# UNITED STATES PATENT AND TRADEMARK OFFICE

APPLICATION NO.	FILING DATE	FIRST NAMED INVENTOR	ATTORNEY DOCKET NO.	CONFIRMATION NO.
09/516,655	03/01/2000	Thomas C. Thompson		3209
7.	590 07/29/2003			
Thomas C Thompson		EXAMINER		
92-543 Kokole PLace Makakilo, HI 96707			GARCIA, ERNESTO	
			ART UNIT	PAPER NUMBER
			3679	
		DATE MAILED: 07/29/2003

**DETAILED ACTION**

FIG. 3

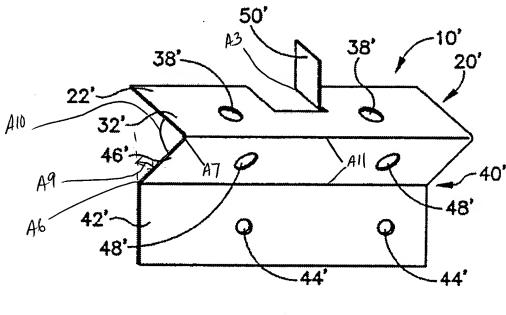
Regarding claim 1, a unitary connector comprising a base web 42', offset, angled, blocking webs 22' and an offset web 46'. One of the blocking webs 22' has a generally right angled bend A3 forming a rafter tab 50'. The base web 42' and the blocking webs 22' are connected by the offset web 46'. The offset web 46' has an acute angled bend A6 attached to the base web 42' and another acute angled bend A7 attached to the blocking webs 22'. However, Leavens fails to disclose each of the

blocking webs **22'** each having a generally right angled bend **A3** forming a rafter tab **50'**. Byers et al. disclose an unitary connector comprising blocking webs **A4** each having a generally right angled bend (col. 3, lines 41-46) forming a rafter tab **12c,12d** to allow a lumber segment to be placed against the rafter tab aligned parallel therewith.

Regarding claim 2, the base web **42'** has a generally flat, generally long-horizontal rectangular shape and nail holes **44'**.

Regarding claim 3, the acute angled bend A6 is a first generally horizontal bend bent A6 at an acute angle A9.

Regarding claim 4, the acute angled bend A7 is a second generally horizontal A7 at an acute angle A10.

Regarding claim 5, the first bend and the second bend are attached to opposite ends **A11** of the offset web **46'** and have generally unequal, acute bends **A9, A10** in opposite directions.
